ADDENDUM NO. 2

September 9, 2022

CROWN POINT HIGH SCHOOL ATHLETIC FIELDS AND SITE IMPROVEMENTS
Crown Point, IN 46307

ADDENDUM TWO

SHEET
C-1.2

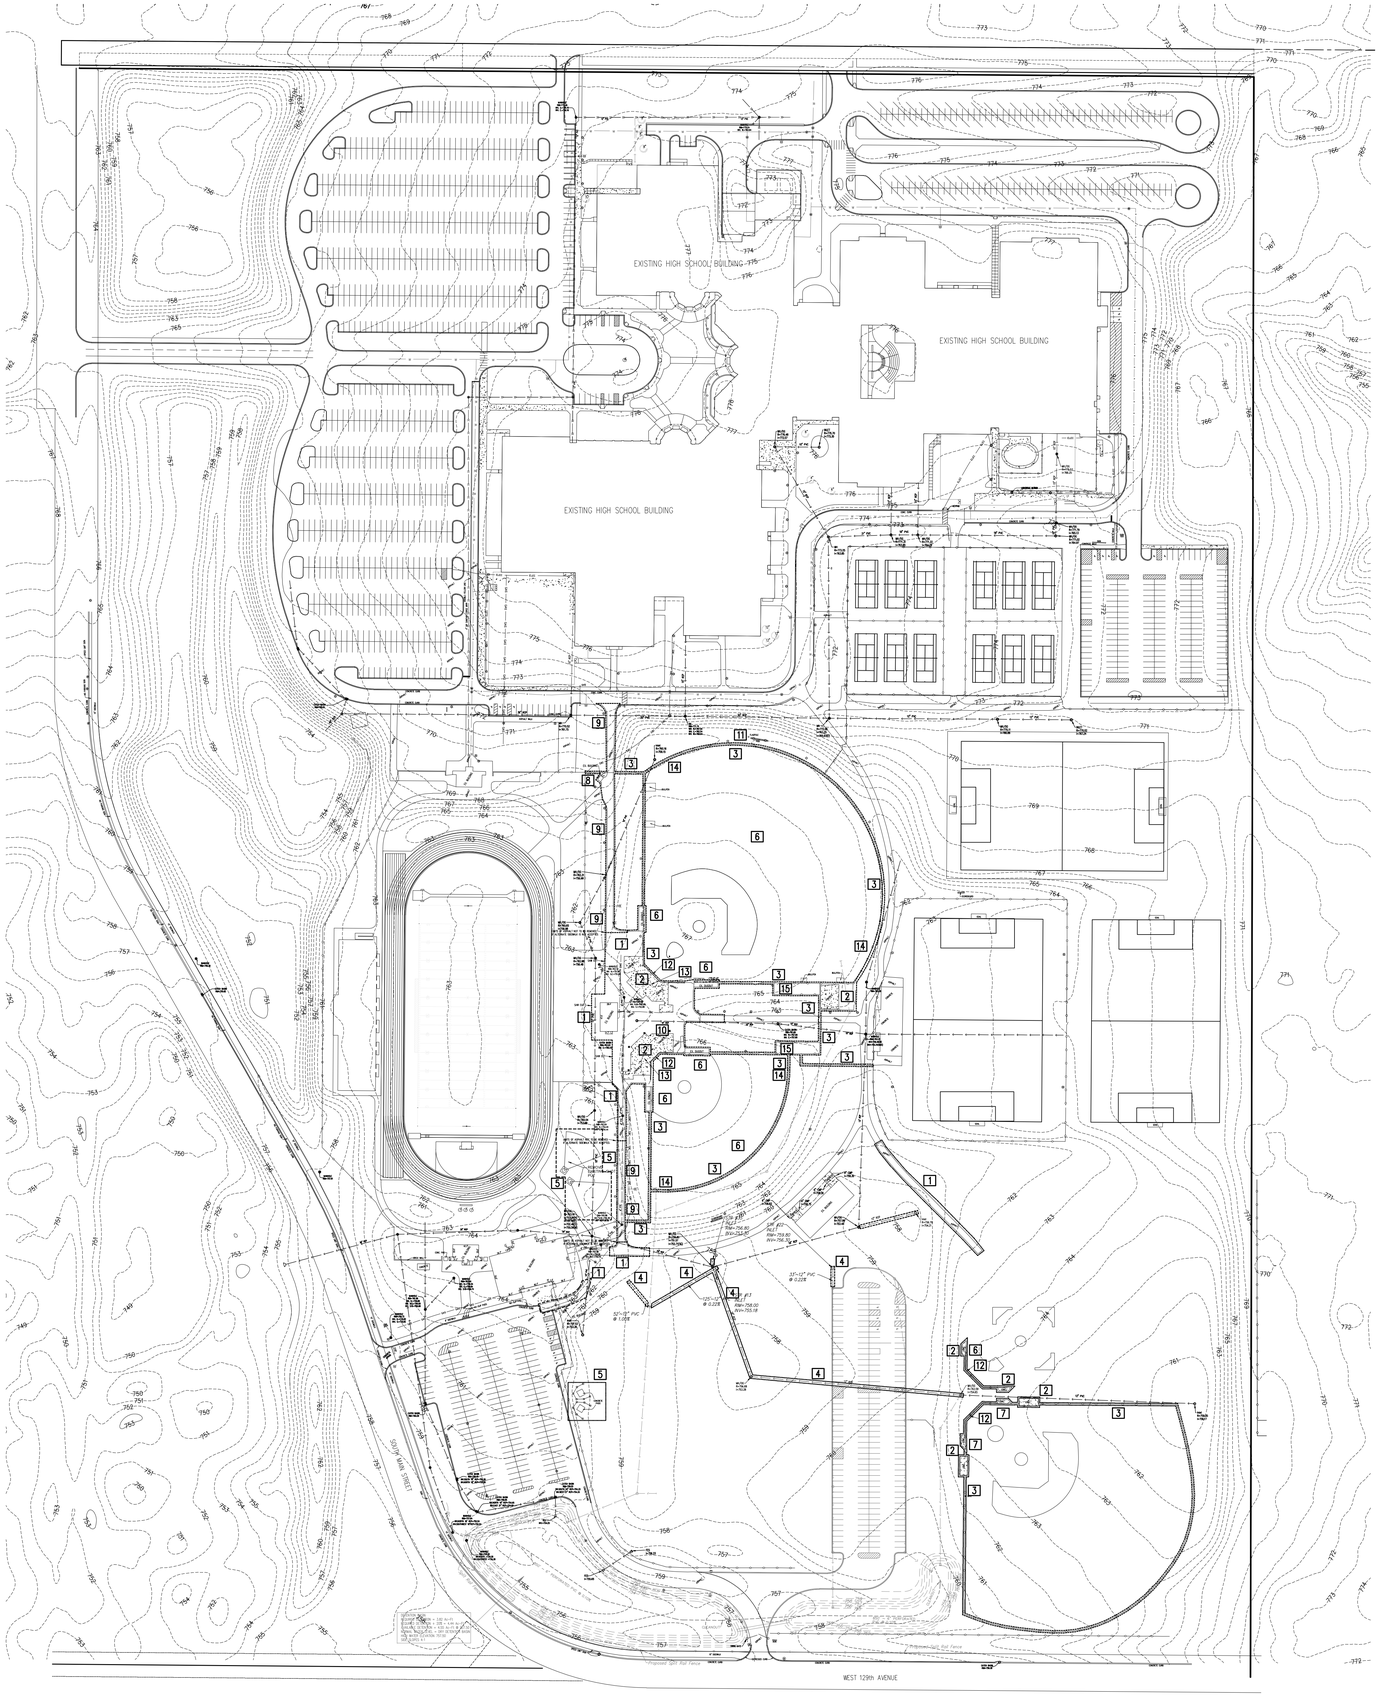
2. Sheet C-1.2

A. Refer to revised, full-size drawing, included in this Addendum, for Demolition Notes 10 through 15 modified and added.

SHEET
C-2.0

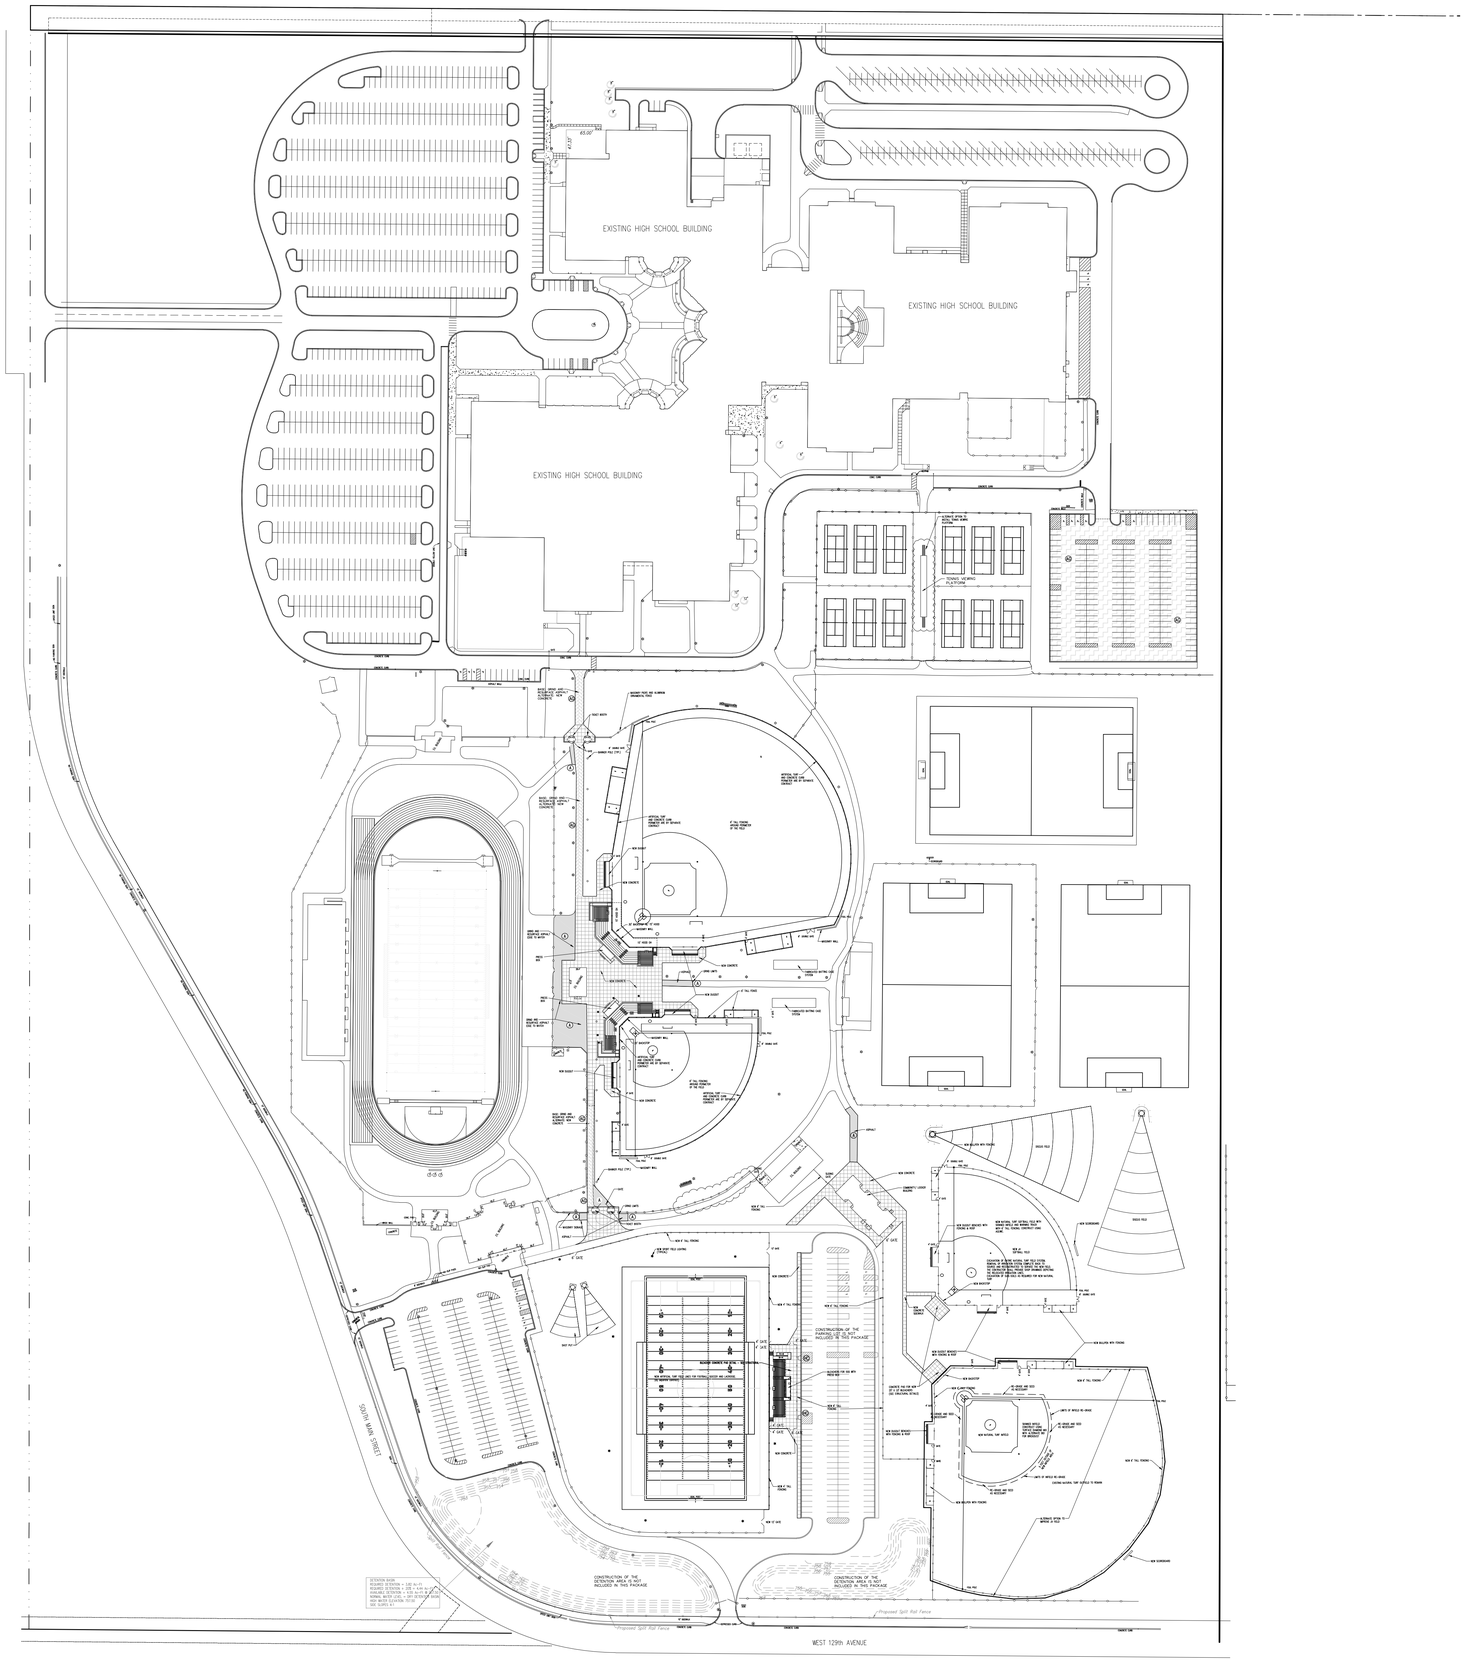
3. Sheet C-2.0

A. Refer to revised, full-size drawing, included in this Addendum, for modified notes for construction of softball and baseball fields.

SHEET
C-2.1

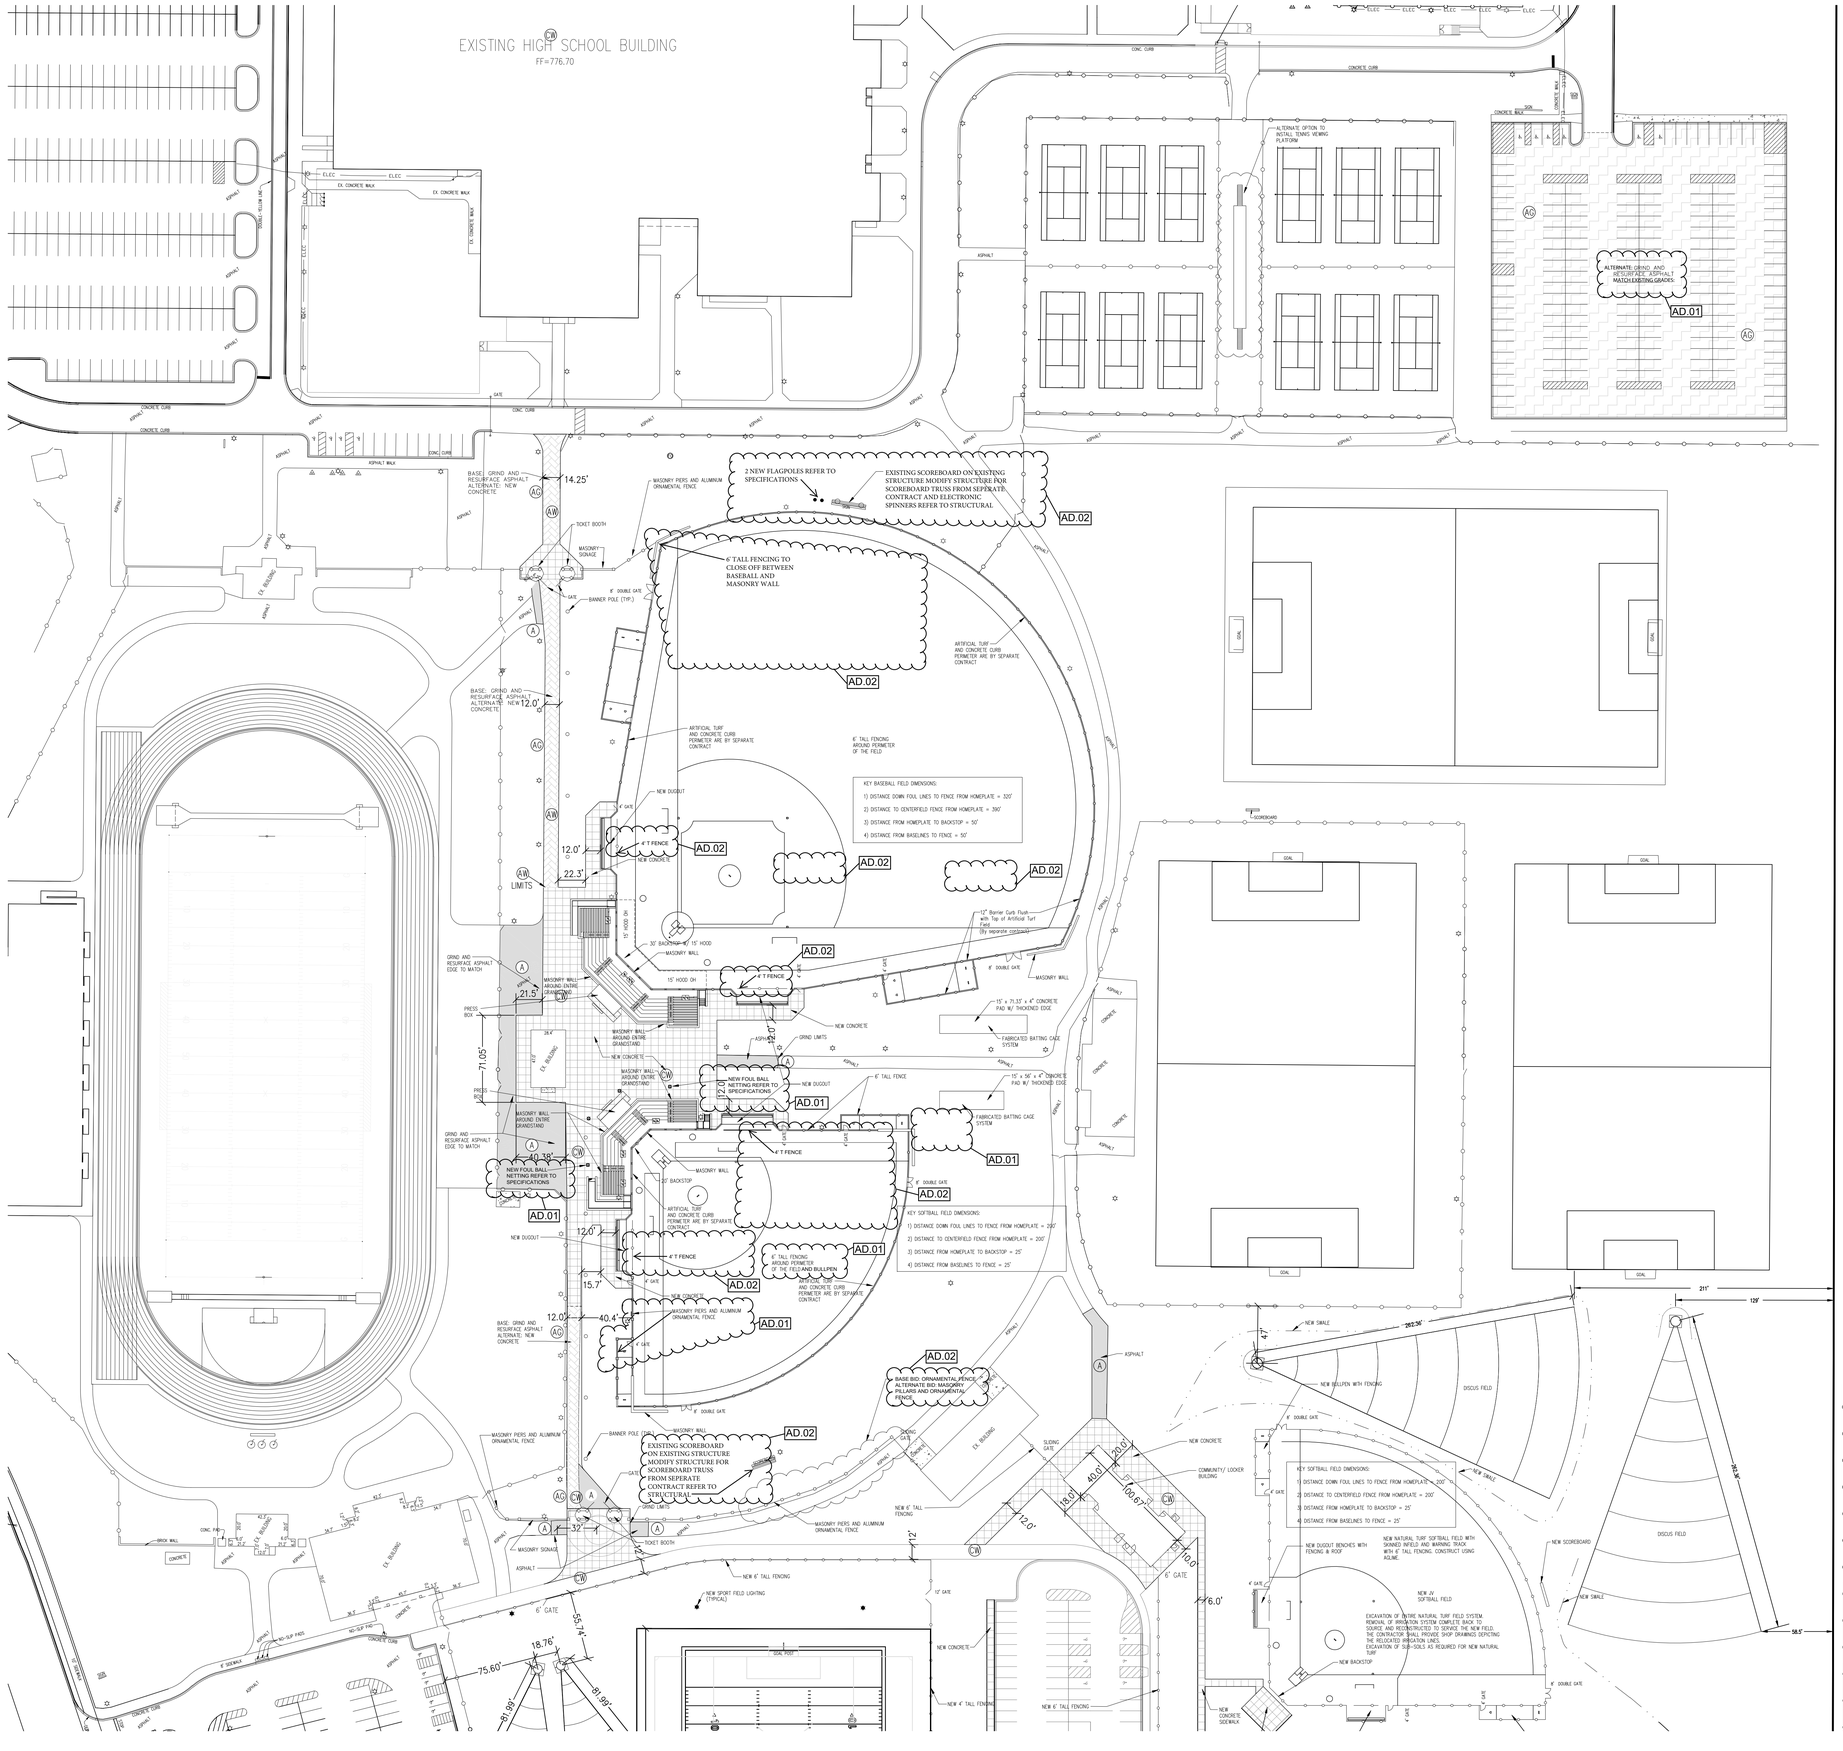
4. Sheet C-2.1

A. Refer to revised, full-size drawing, included in this Addendum, for revised plan notes as indicated on drawing.

SHEET
C-2.1B

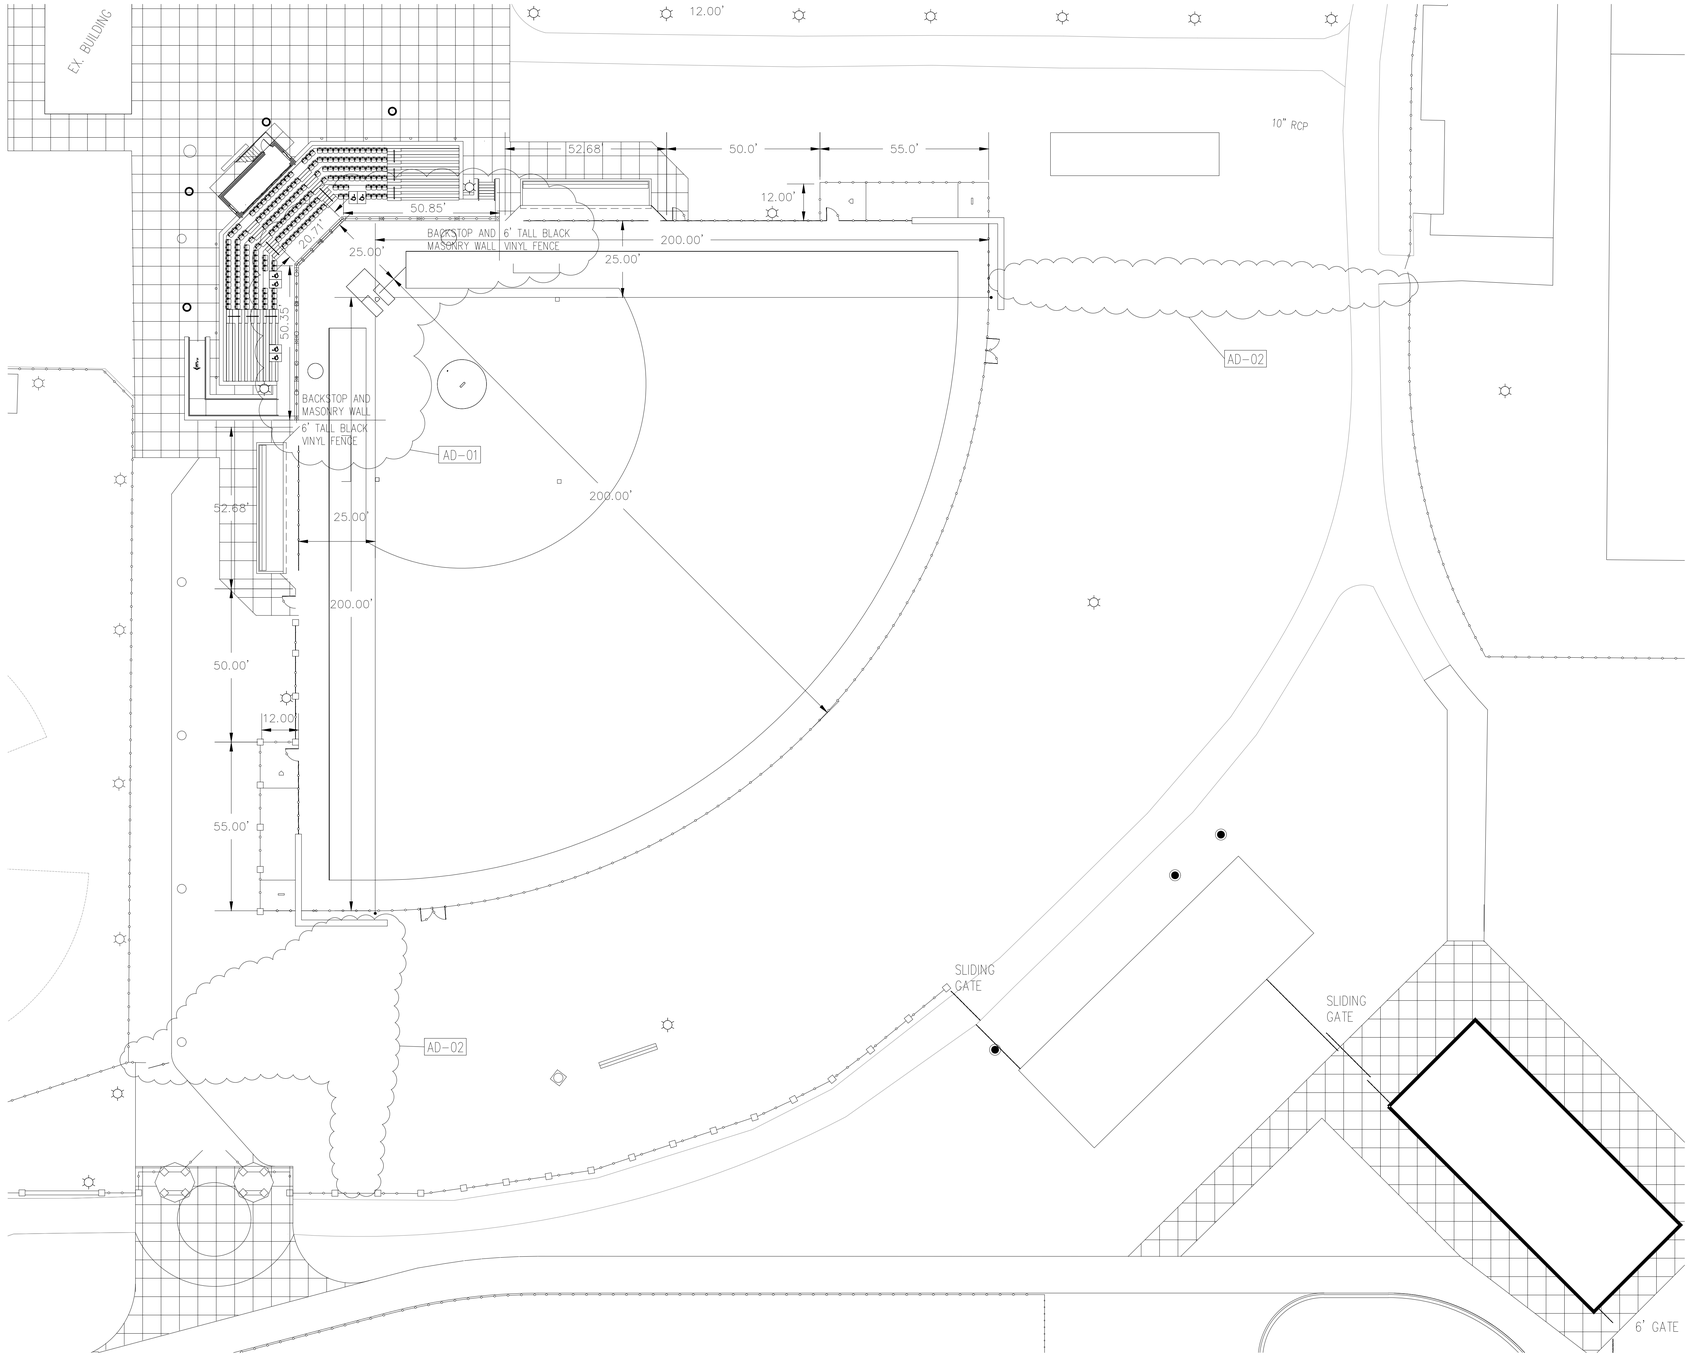
5. Sheet C-2.1B

A. Refer to revised, full-size drawing, included in this Addendum, for revisions.
